One Earth Solar Farm

A57 Access Note

Document Reference: EN010159/APP/9.39

A57 Access Strategy Review

A3.1.1 Problem 4

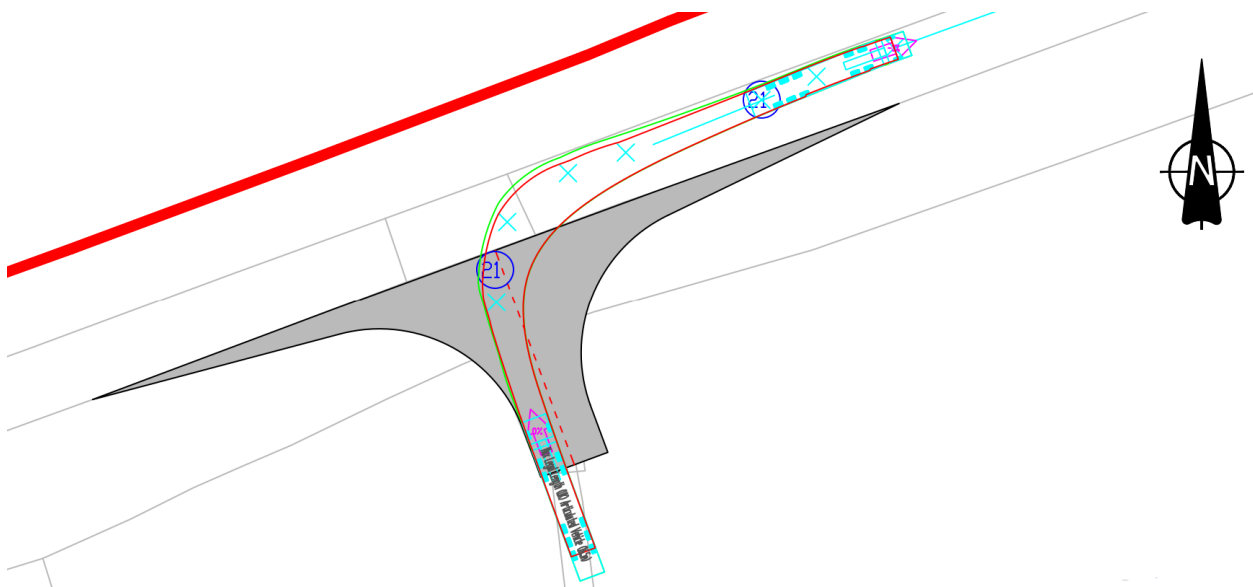
Undertake topographical survey at the next design stage, ensuring levels are accounted for and adequate rainwater drainage through the junction is catered for.

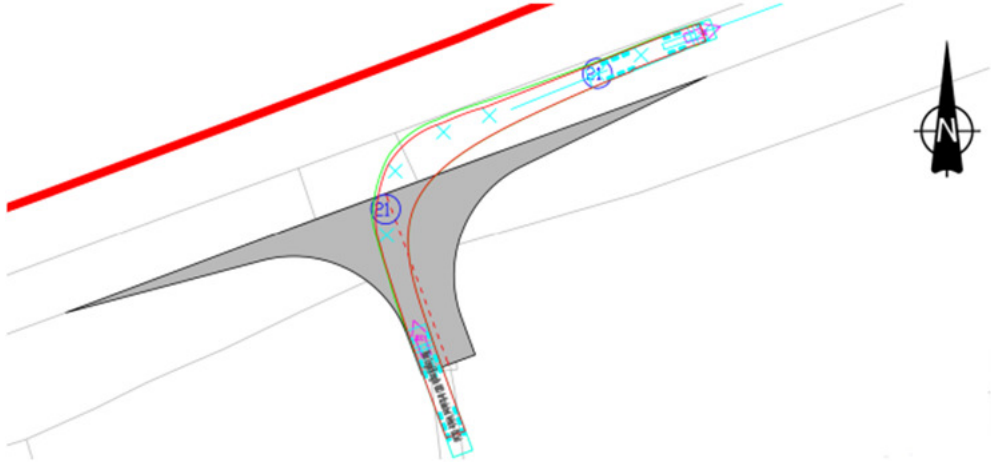
RSA Problem 4 (A3.1.1)	
RSA Problem Description:	<p>The inset D swept path showing an articulated vehicle turning right onto A57 encroaches the opposing lane prior to giving way to traffic on the A57. However, drivers egressing the site would likely approach the give way on the left side of the centre line and then turn right. Therefore, it is unclear whether an articulated lorry would encroach the embankments if they started their manoeuvre on the left side of the centre line, which could lead to loss of control collisions.</p> 
RSA Recommendation:	Undertake swept path analysis, having right turning articulated vehicles begin their manoeuvre on the left side of the centre line at the give way markings, and adjust the proposals to suit.
Design Organisation Response:	Agreed. The junction design will be refined during the detailed design phase to address any potential conflict once the exact vehicle dimensions have been confirmed with the contractors.
